MEMORANDUM

SUBJECT: Item No. 3.2, 8 November 2023 DDP - DA2022/2207 - 30 Abernethy Street SEAFORTH - Demolition works and construction of a dwelling house including swimming pool

The purpose of this memo is to advise the Panel of three matters in relation to Item 3.2 to be considered at the 8 November DDP meeting following publication of the agenda and the assessment report.

Drawing Title DRIVEWAY PLAN			
FOR DEVELOPMENT APPLICATION			
Scale 1: 50	@A3	Date: 02.11.23	
2011 Project no.	DA Drawing Phase.	A508 Drawing No.	4 Rev

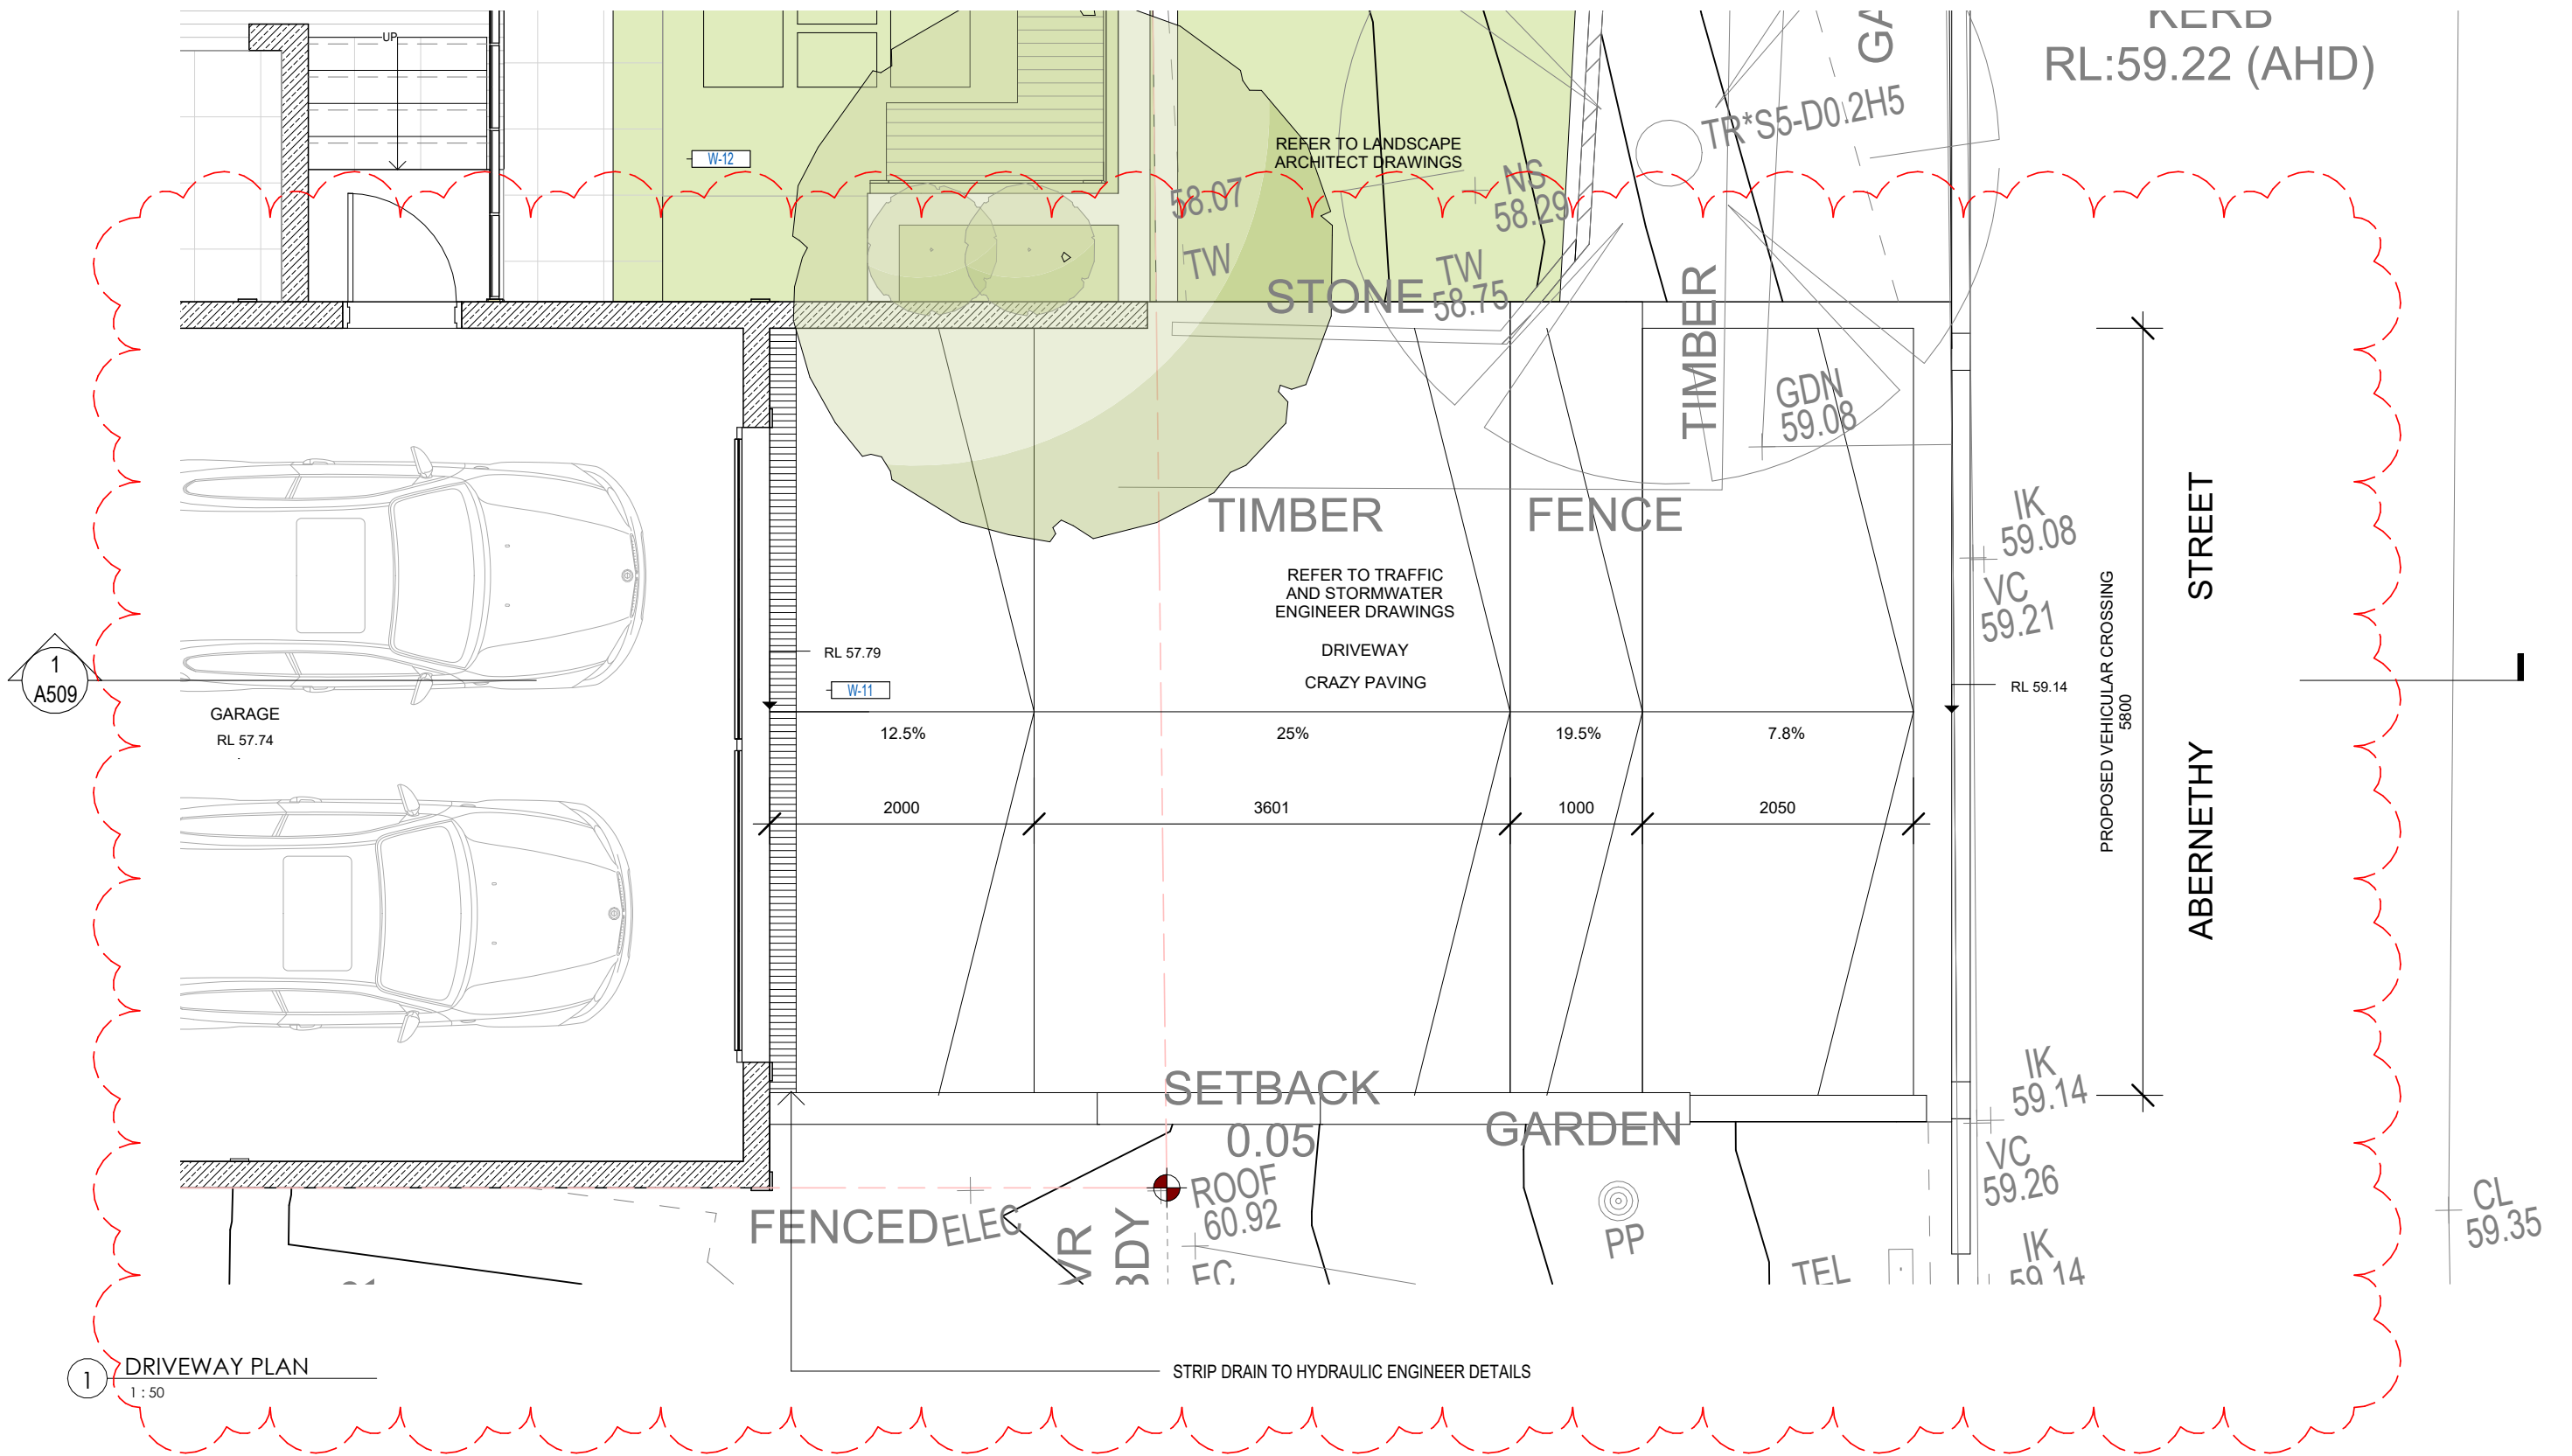
This letter addresses the comments provided by Northern Beaches Council regarding the gradients of the driveway proposed, which will be used to gain vehicular access to the site. The design of the driveway has been amended to generally meet the requirements of the Northern Beaches Council *Standard Drawing – Driveway Profile – Maximum Low (ML)* (Council Profile), which has been reproduced in **Annexure B** for reference. Sections of the proposed driveway profile along both sides of the ramp are provided in **Annexure C**.

The proposed design matches the Council Profile other than the steepness and length of the transition at the base of the ramp, where a two-metre long transition at 12.5% is proposed where the Council Profile allows for a 1.5-metre long transition at 10%. The 2m long, 12.5% transition accords to the requirements of Australian Standard 2890.1:2004 and will facilitate vehicle access to and from the parking area without scraping the underside of a vehicle.

- 1) Amended Plans submitted on portal 6/07/2023 with the following changes:
 - a) Raised Garage level to accommodate driveway amendment. Garage level was raised 373mm;
